Clonburris T1

Street Hierarchy, Design & Layout Submission

For Proposed Residential Development
Clonburris T1, Co. Dublin

Compliance Submission in Accordance with
Planning Condition no. 2

Plan of Street 5 / Drawing Ref: CLB-1-00-SW-ZZ-DR-CWO-AR-1000

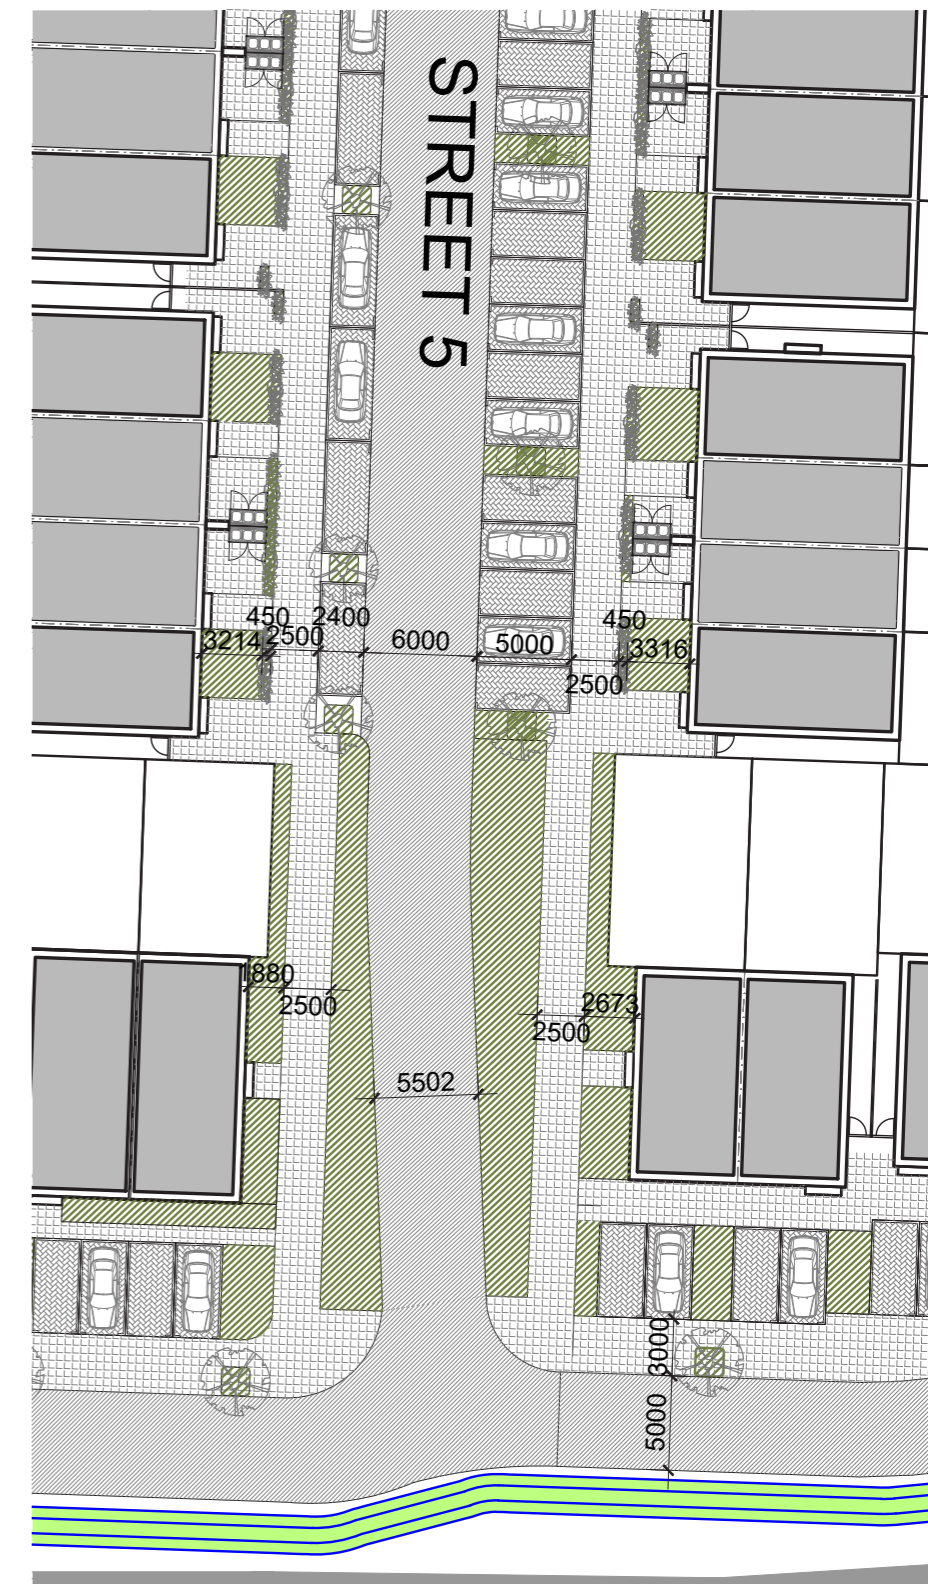
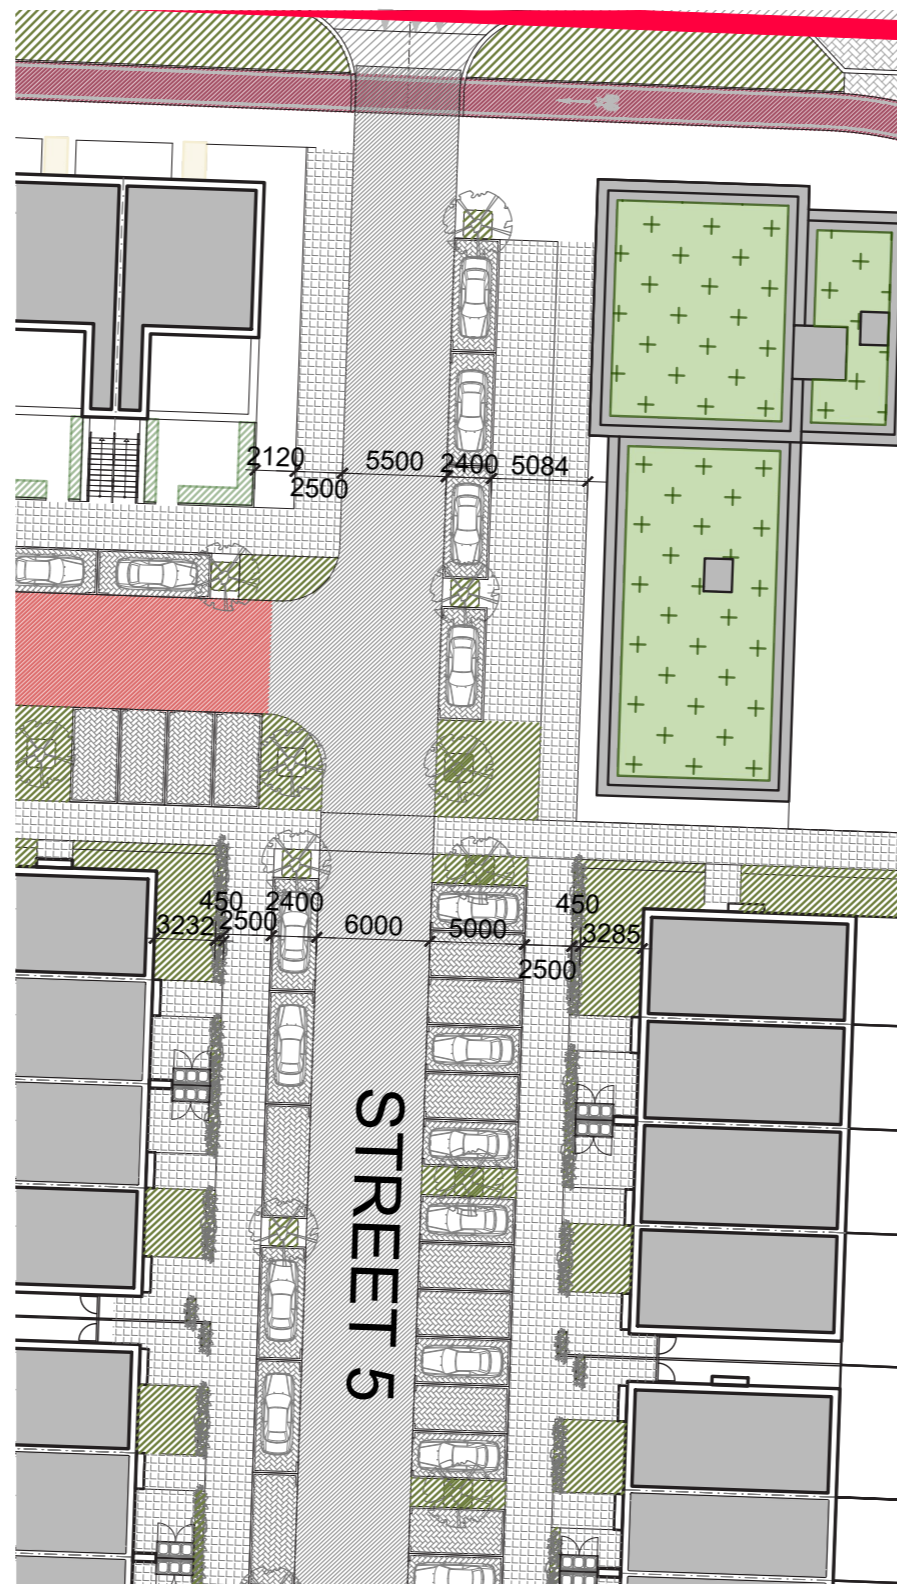
2(f) Street 5: (i) The element between the community building and dwelling 309 is 18m wide. Given the width, the street shall be redesigned in general accordance with Figure 2.2.6 Indicative Local Street B. The following detail shall be provided.

- The street shall have a carriageway width of no less than 5 meters and no more than 5.5 meters;
 - Only parallel parking shall be provided and it shall be a minimum of 2.4m deep.

- A footpath width of between 2.5 and 4 meters shall be provided;
 - Privacy strips/short gardens that range from 1 to 3 metres in depth shall be provided

- Street trees shall be provided in accordance with Condition 7
- (ii) The element south of the community building is 25m wide. This shall be redesigned in general accordance with Figure 2.2.6 Indicative Local Street A. The following detail shall be provided.

- The street shall have a carriageway width of no less than 5 meters and no more than 6 meters; 6m shall be provided for reversing if perpendicular parking is proposed

- Perpendicular parking bays shall be a minimum of 5m deep and parallel shall be a minimum of 2.4m.
 - At any point along the road, perpendicular parking shall be provided on one side only;

- A footpath width of between 2.5 and 4 meters shall be provided;
 - Privacy strips/short gardens that range from 1 to 3 metres in depth shall be provided

Street 5 has been designed in accordance with the conditions. The element between the community building and dwelling 309 is designed in general accordance with Figure 2.2.6 'Indicative Local Street B'.

- The street has a carriageway width of 5.5 meters; only parallel parking has been provided and it is 2.4m deep; a footpath of 2.5 meters has been provided; and street trees in accordance with Condition 7 have been provided.

The element south of the community building is designed in general accordance with Figure 2.2.6 'Indicative Local Street A'.

- The street has a carriageway width of 6 meters; perpendicular bays are 5m deep and parallel are 2.4m deep; perpendicular parking is provided on one side only; a footpath of 2.5 meters has been provided; privacy strips of between 1.8 and 3.8 meters have been provided; and street trees in accordance with Condition 7 have been provided.

Plan of Street 7 / Drawing Ref: CLB-1-00-SW-ZZ-DR-CWO-AR-1000

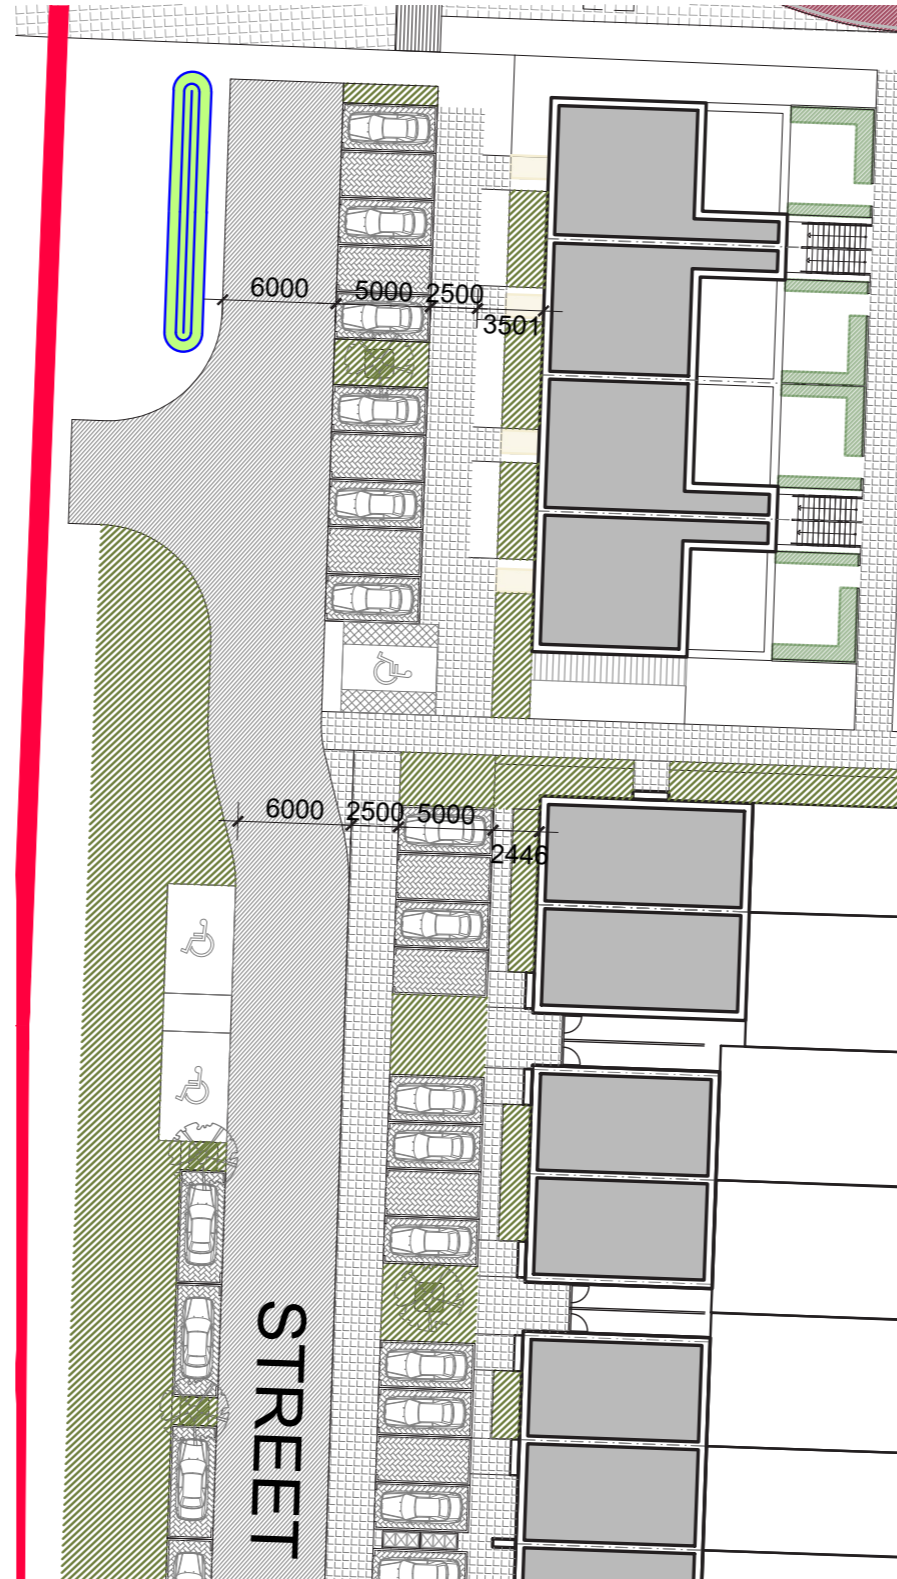
2 (h) Street 7: This shall be redesigned in general accordance with Figure 2.2.6 Indicative Local Street A. The following detail shall be provided.

- The street shall have a carriageway width of no less than 5 meters and no more than 6 meters; 6m shall be provided for reversing if perpendicular parking is proposed
- Perpendicular parking bays shall be a minimum of 5m deep and parallel shall be a minimum of 2.4m.
- At any point along the road, perpendicular parking shall be provided on one side only;
- A footpath width of between 2.5 and 4 meters shall be provided;
- Privacy strips/short gardens that range from 1 to 3 metres in depth shall be provided
- Street trees shall be provided in accordance with Condition 7
- If feasible without negatively impacting on the open space to the west, parallel car parking may be provided adjacent to the park.

Street 7 has been designed in accordance with Figure 2.2.6 Indicative Local Street A.

- The street has a carriageway width of 6 meters; 6m has been provided for reversing as perpendicular parking is proposed
- Perpendicular parking bays are a minimum of 5m deep and parallel are a minimum of 2.4m.
- Perpendicular parking is provided on one side of the road only;
- A footpath width of 2.5 meters has been provided;
- Privacy strips of 2.4 metres in depth have been provided;
- Street trees have been provided in accordance with Condition 7;
- Parallel car parking has been provided adjacent to the park.

Plan of Street 8 / Drawing Ref: CLB-1-00-SW-ZZ-DR-CWO-AR-1000

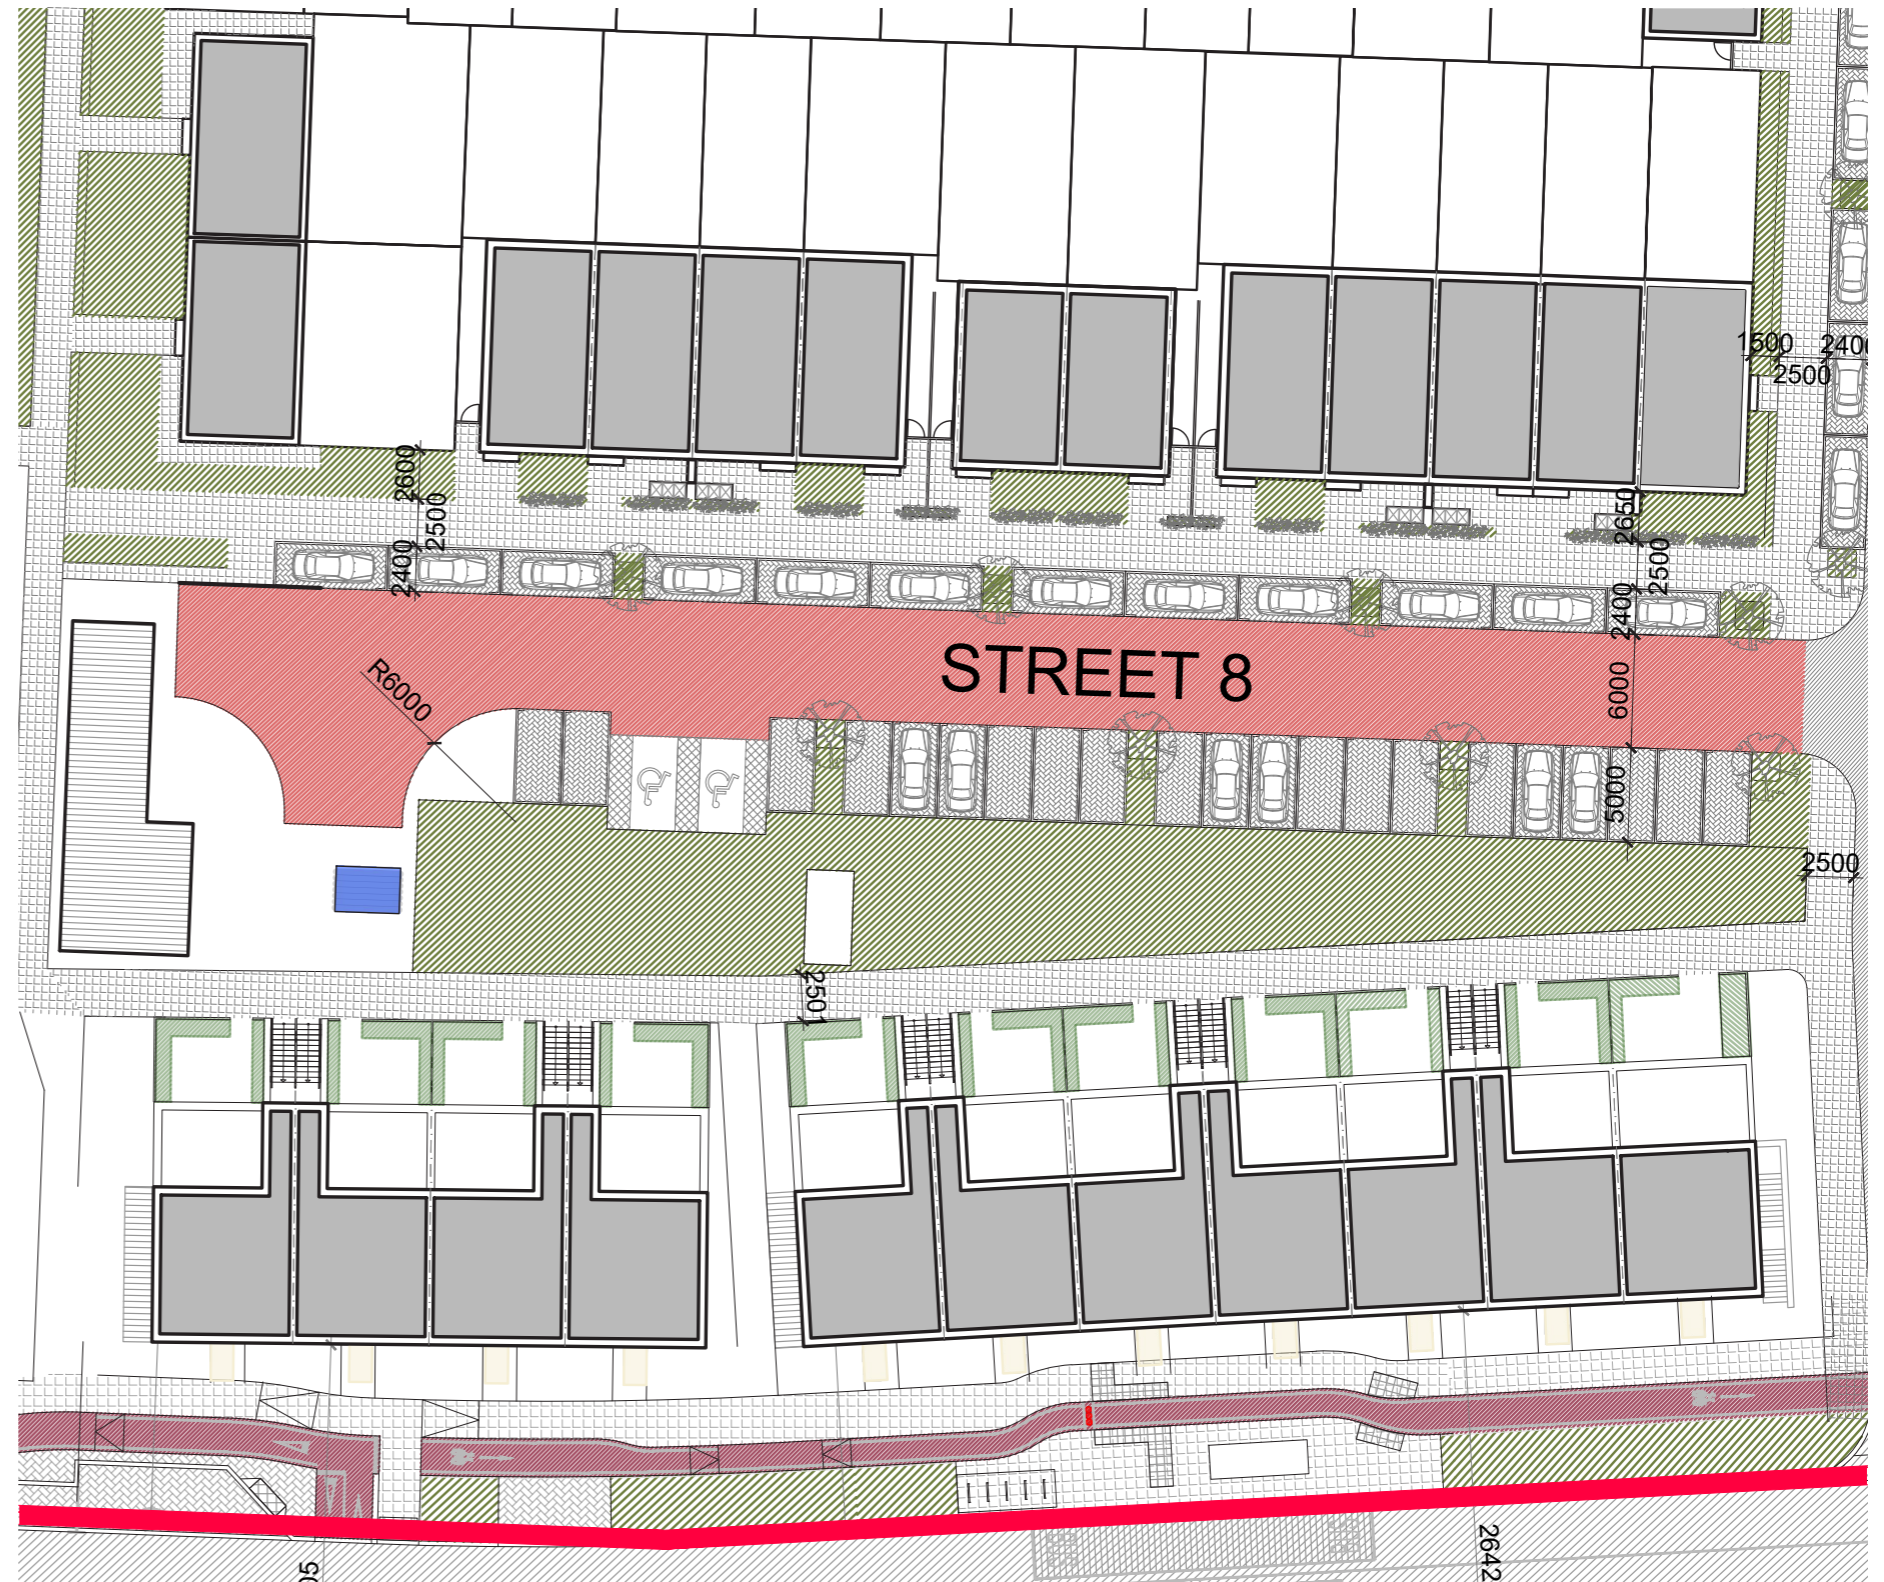
2 (i) Street 8: This shall be redesigned in general accordance with Figure 2.2.6 Indicative Local Street A. The following detail shall be provided:

- The street shall have a carriageway width of no less than 5 meters and no more than 6 meters; 6m shall be provided for reversing if perpendicular parking is proposed
- Perpendicular parking bays shall be a minimum of 5m deep and parallel shall be a minimum of 2.4m.
- At any point along the road, perpendicular parking shall be provided on one side only;
- A footpath width of between 2.5 and 4 meters shall be provided;
- Privacy strips/short gardens that range from 1 to 3 metres in depth shall be provided
- Street trees shall be provided in accordance with Condition 7

Street 8 has been designed in accordance with Figure 2.2.6 Indicative Local Street A.

- The street has a carriageway width of 6 meters; 6m has been provided for reversing as perpendicular parking is proposed
- Perpendicular parking bays are a minimum of 5m deep and parallel are a minimum of 2.4m.
- Perpendicular parking is provided on one side of the road only;
- A footpath width of 2.5 meters has been provided;
- Privacy strips of 2.6 metres in depth have been provided;
- Street trees have been provided in accordance with Condition 7.
